**BCC DS**  
**RECEIVED**  
08-MAY-2026  
**APPLICATION REF**  
A007020190

DA Set - 21.02.2024.

DA Set - 15.02.2026.

Rev\_06

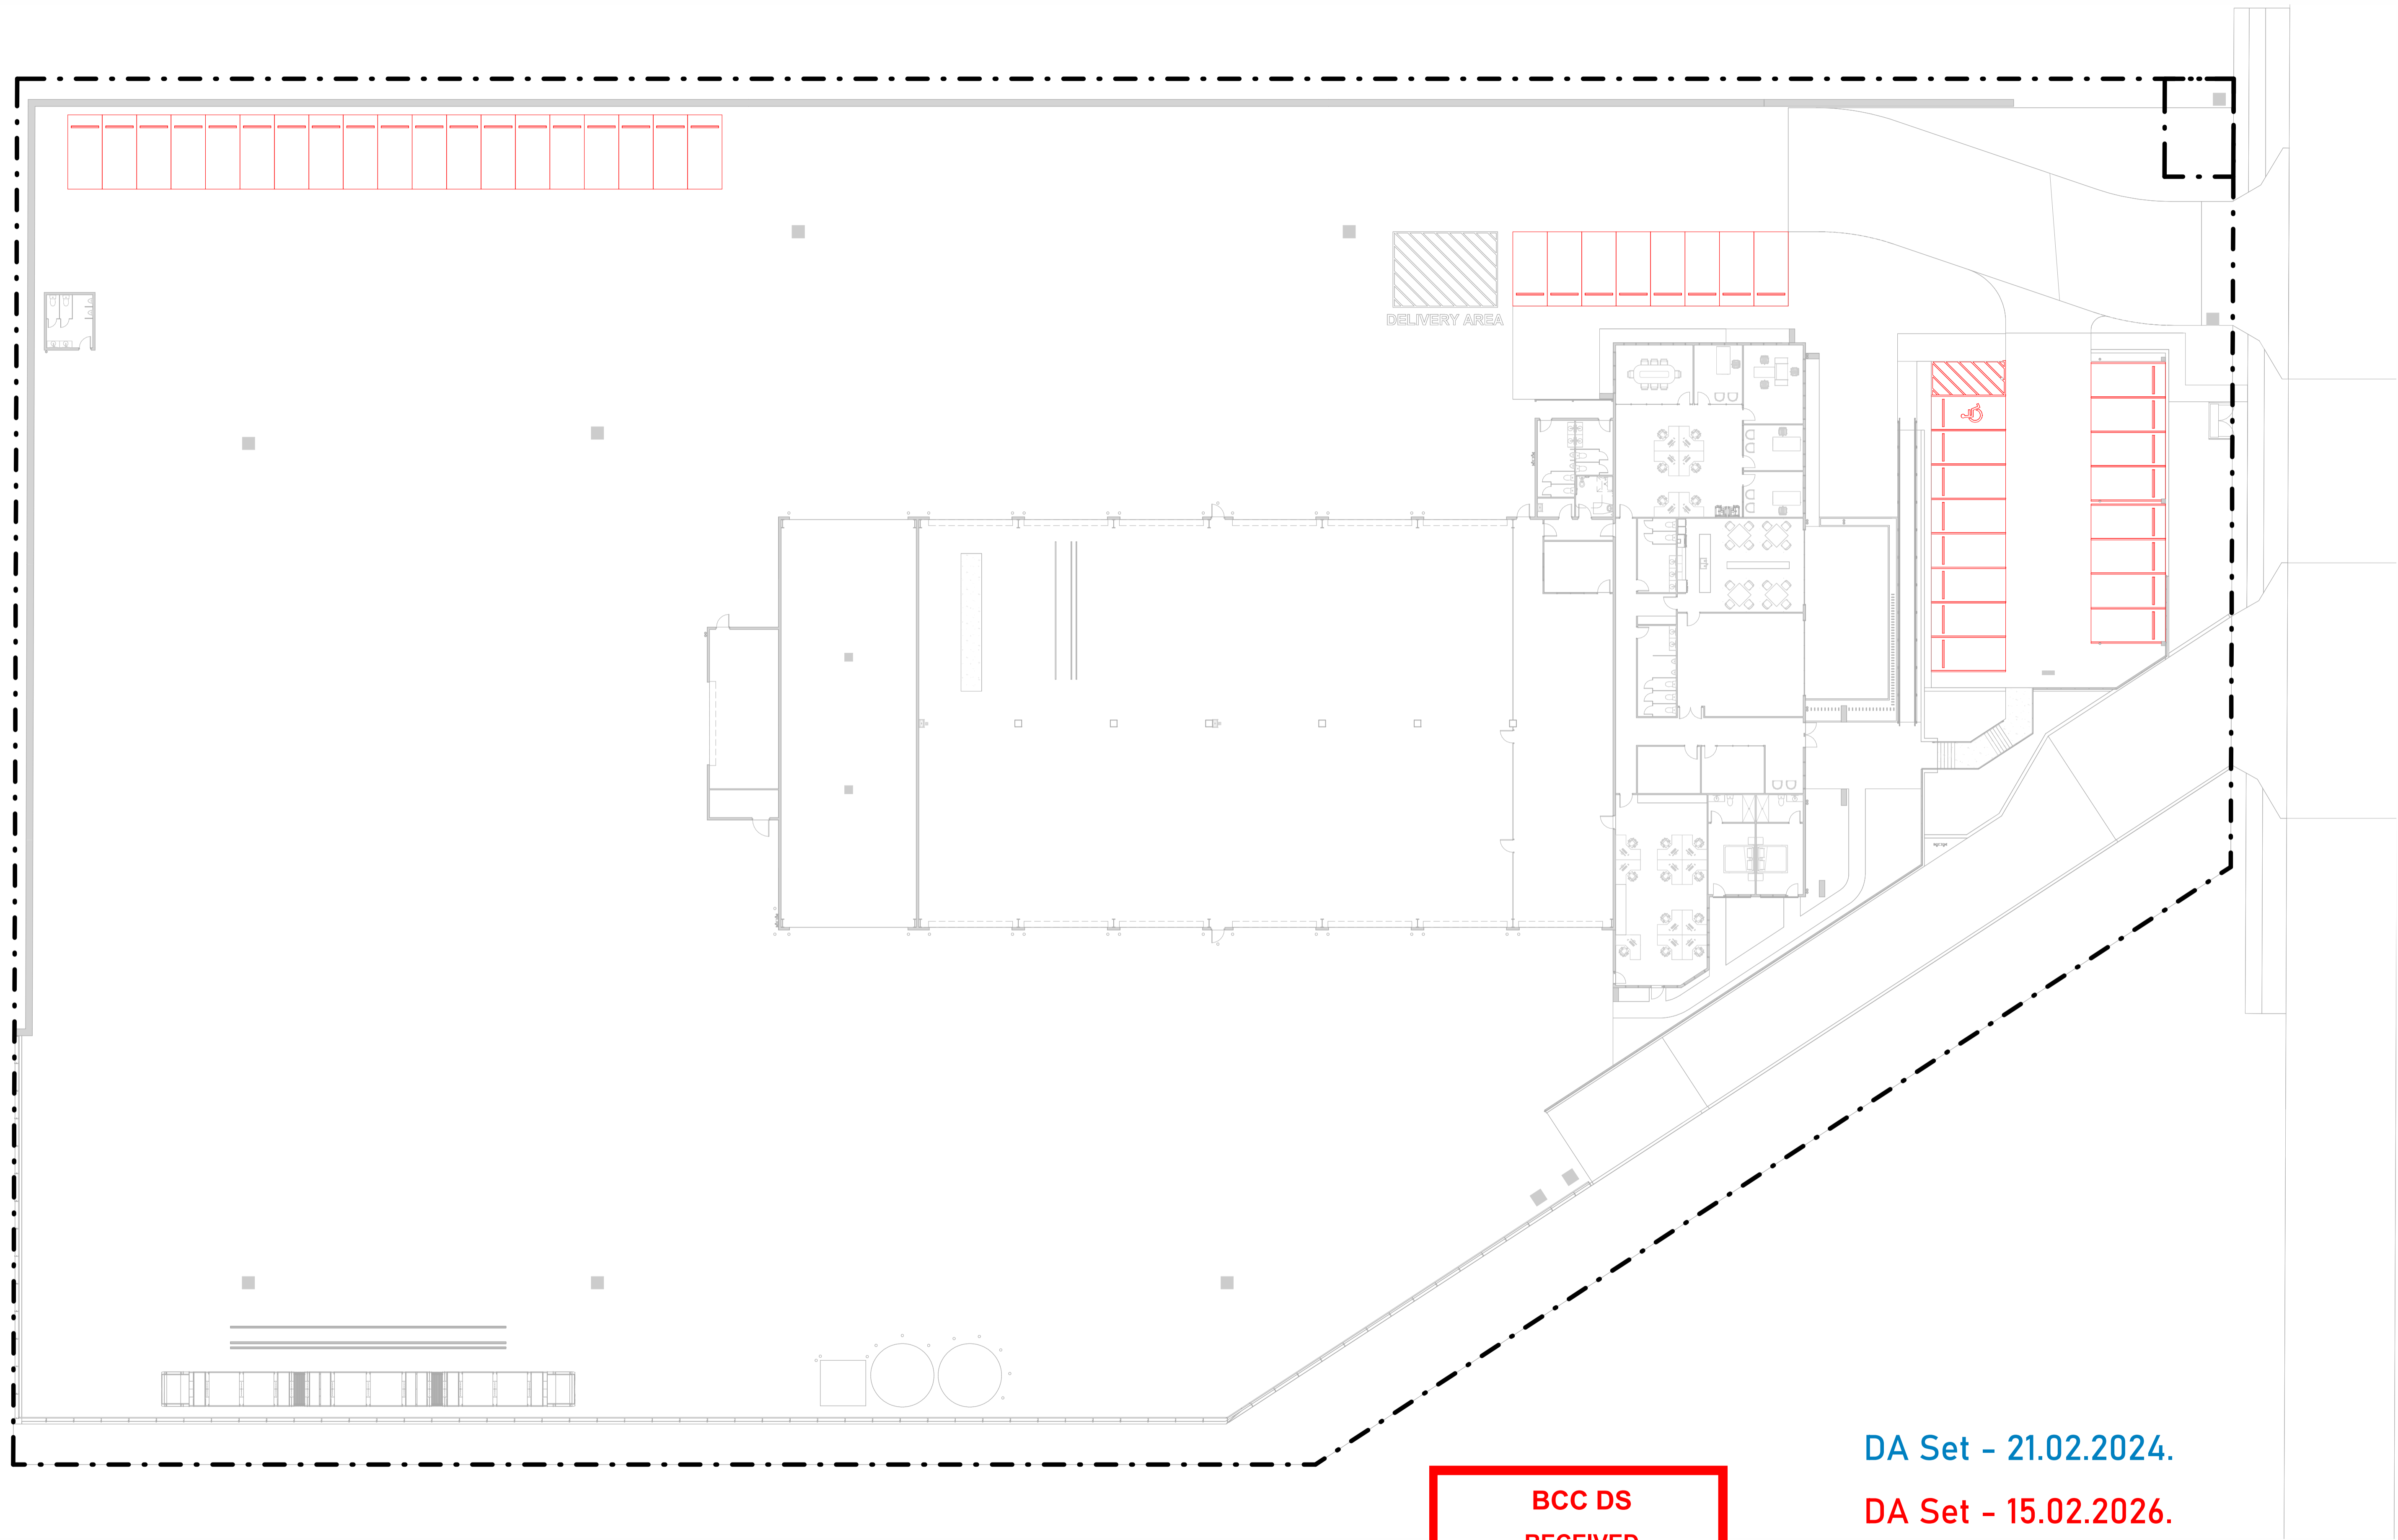
06. The number of car parking spaces has increased.

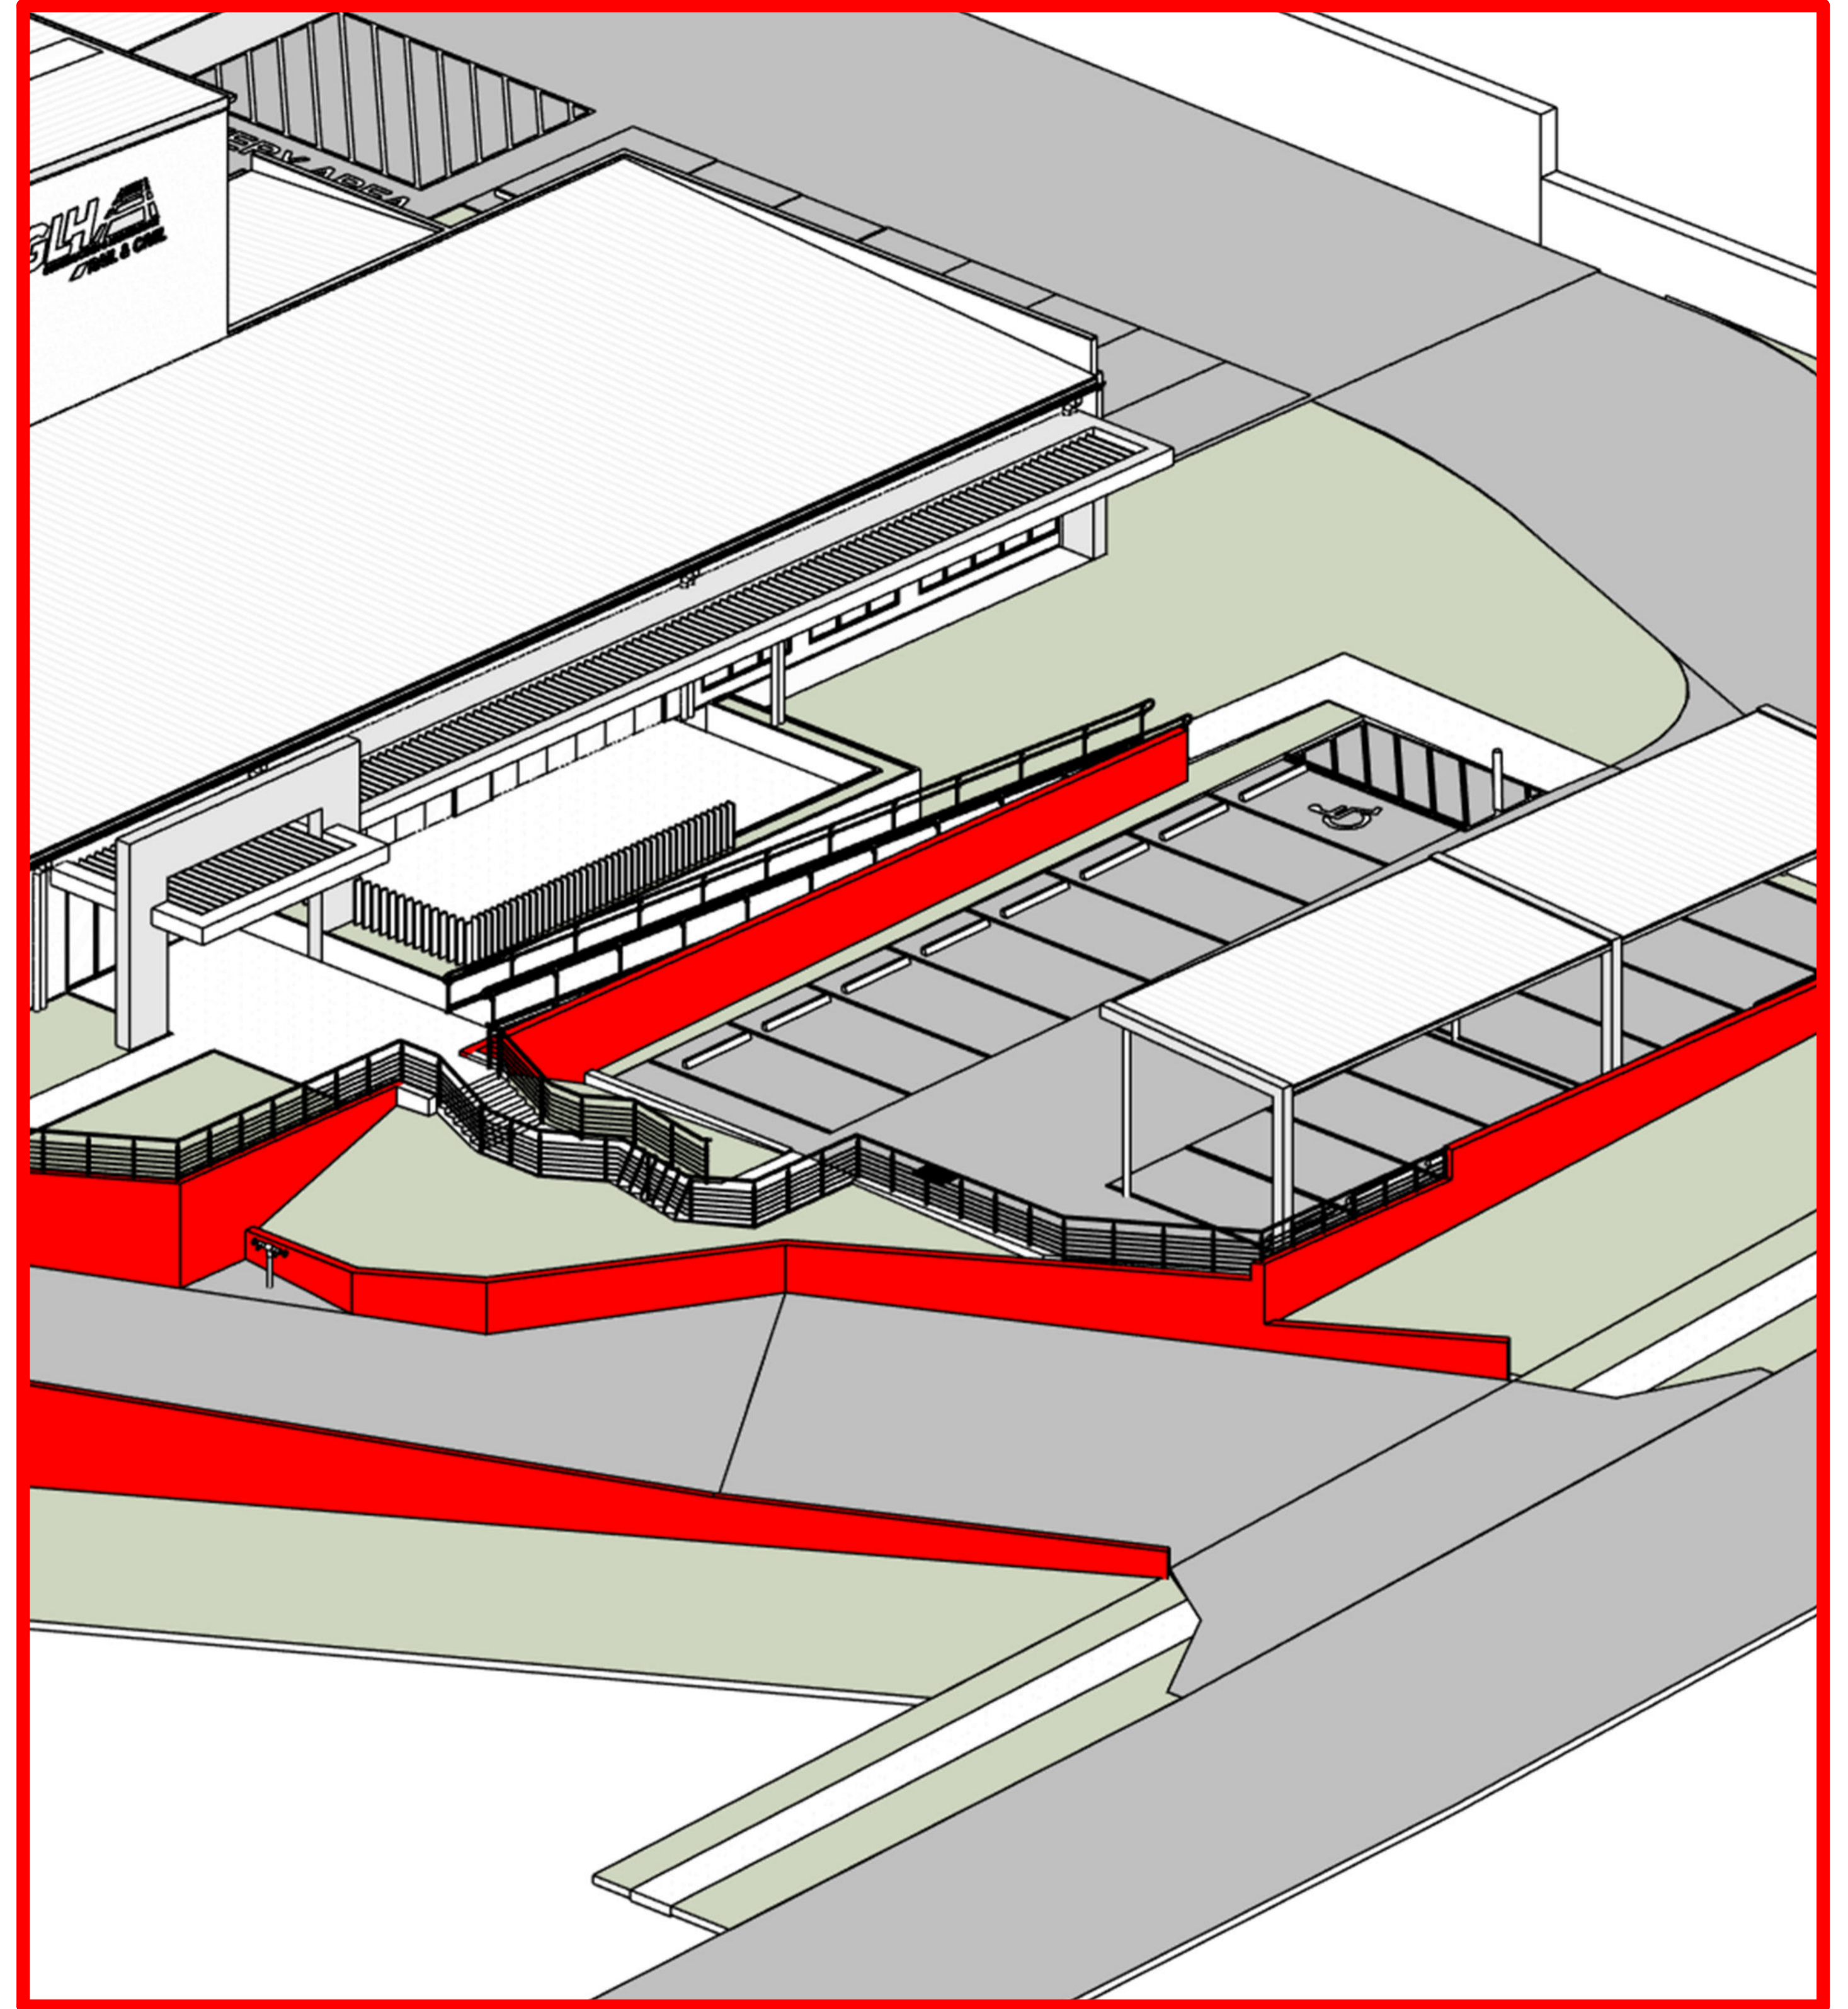
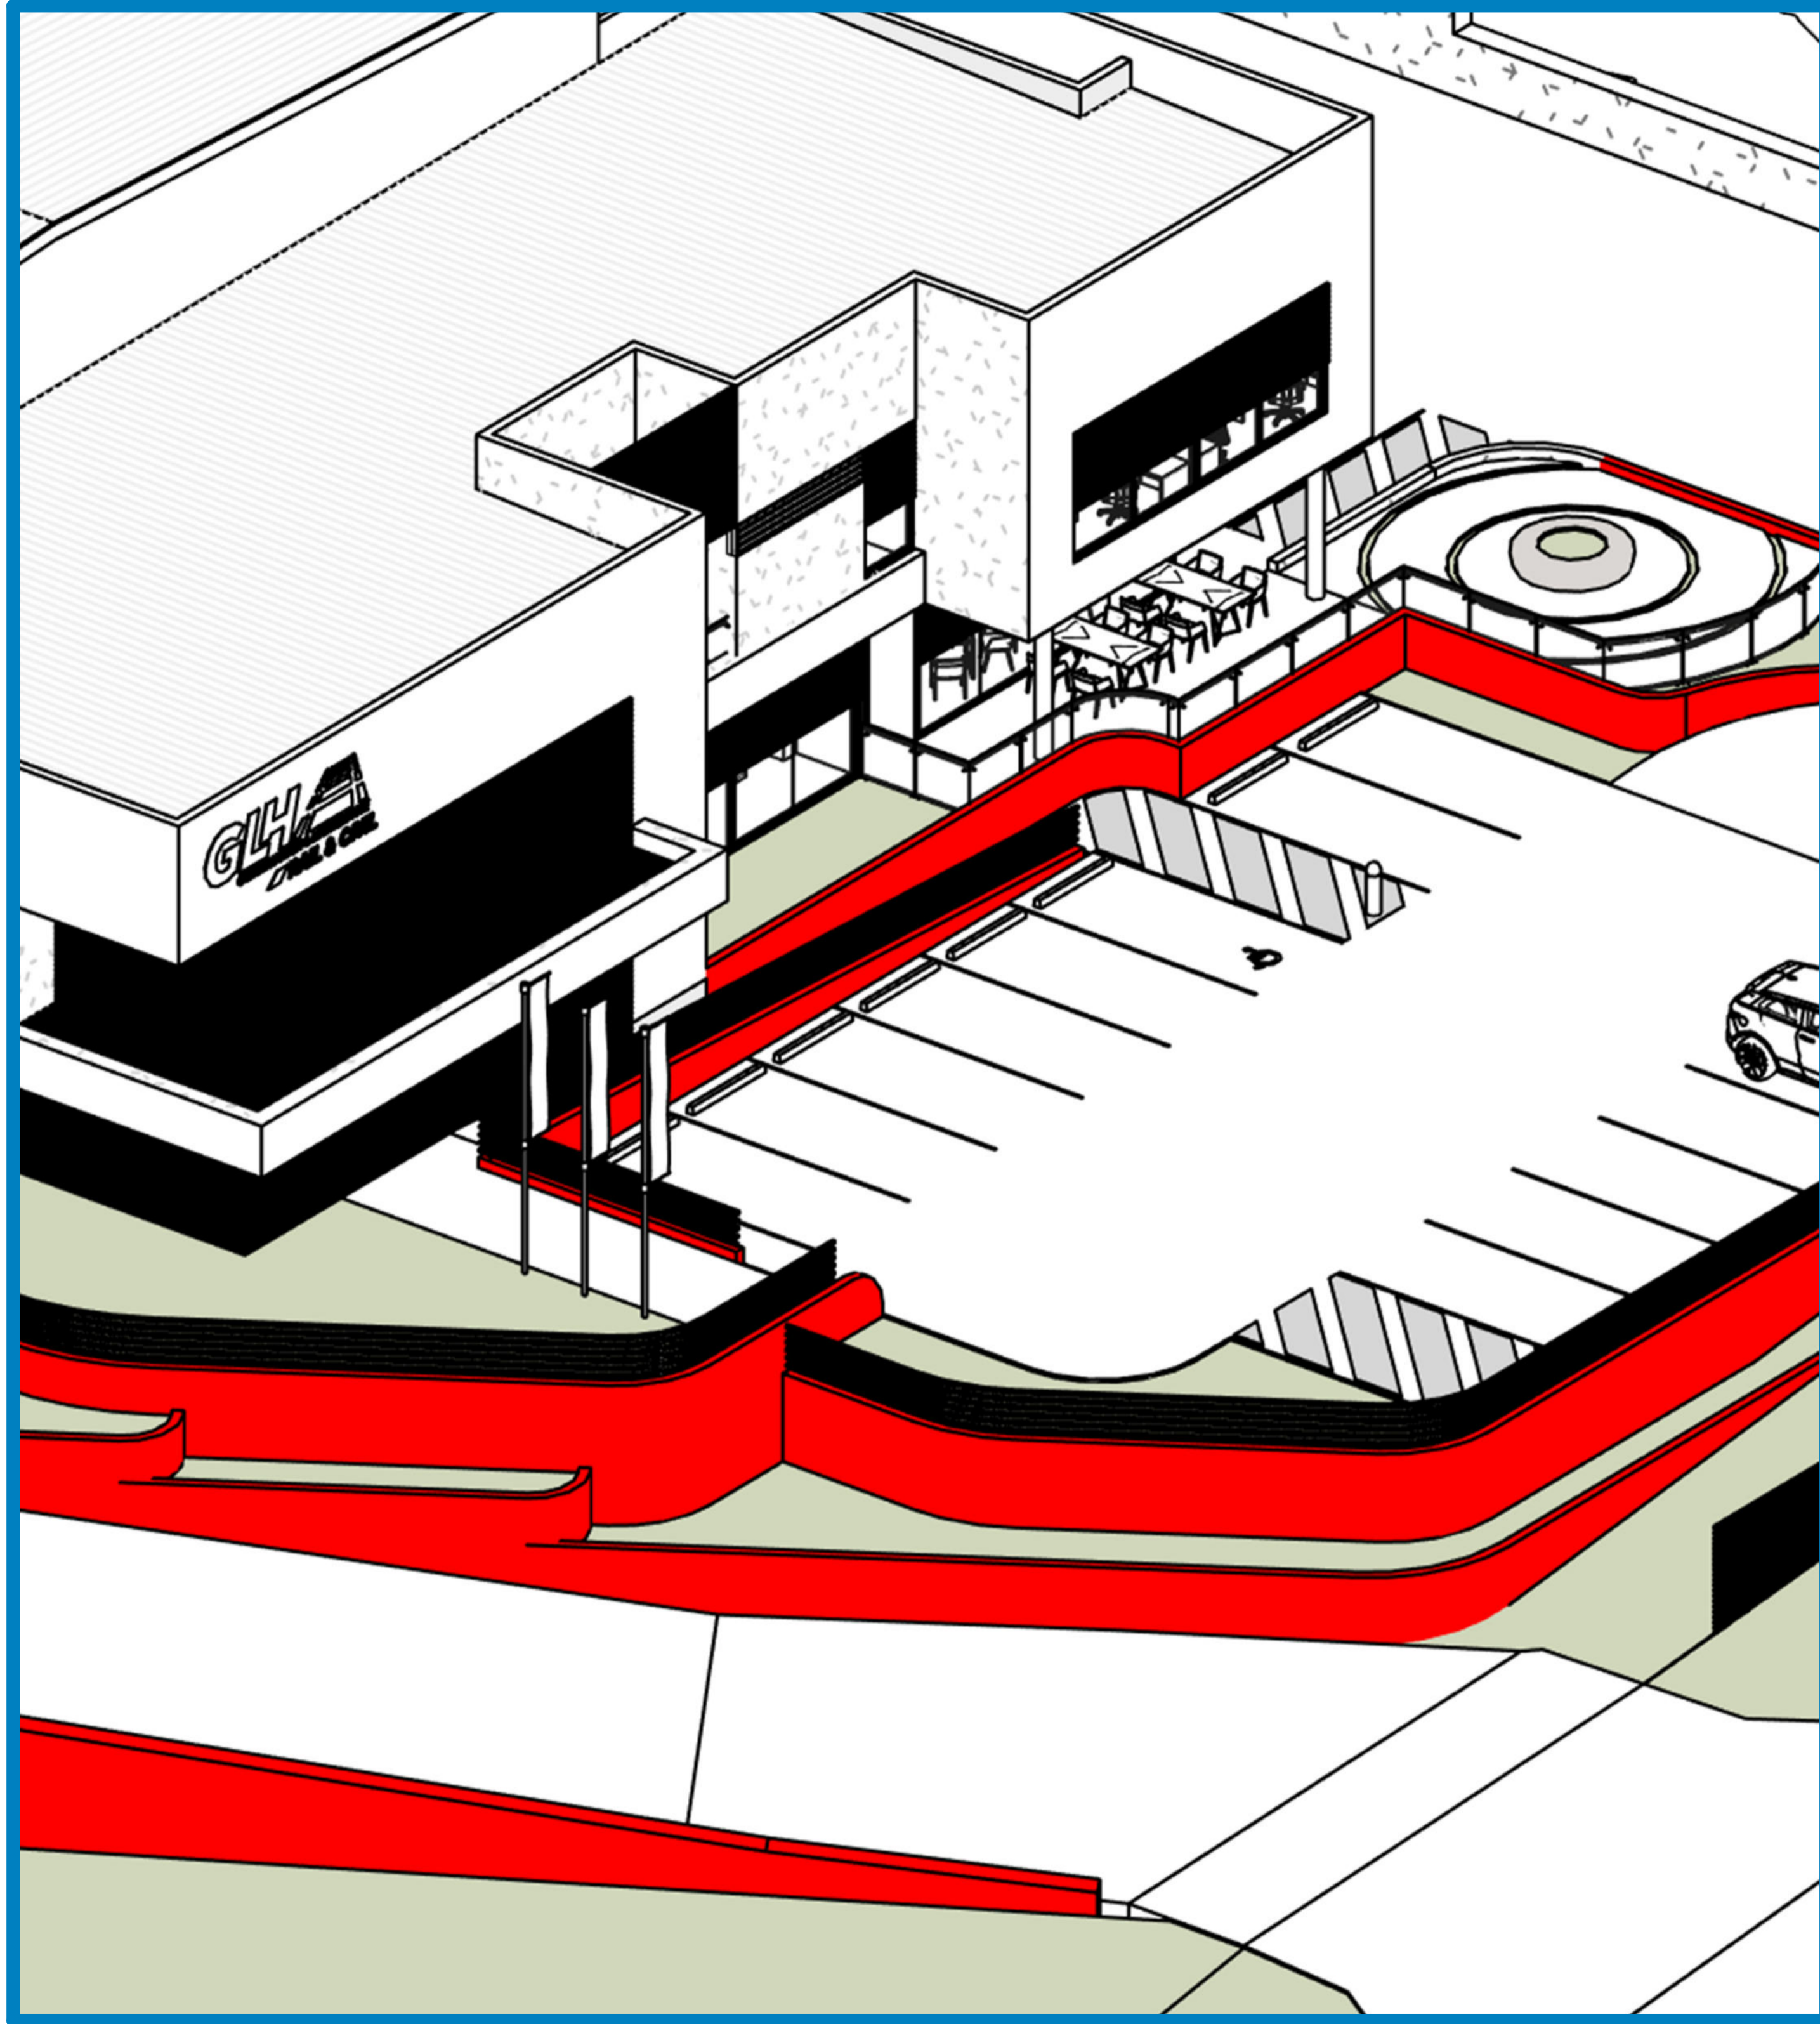
07. The front car park has been redesigned, and a canopy has been added.

08. The number of retaining walls at ground level in front of the building has been reduced.
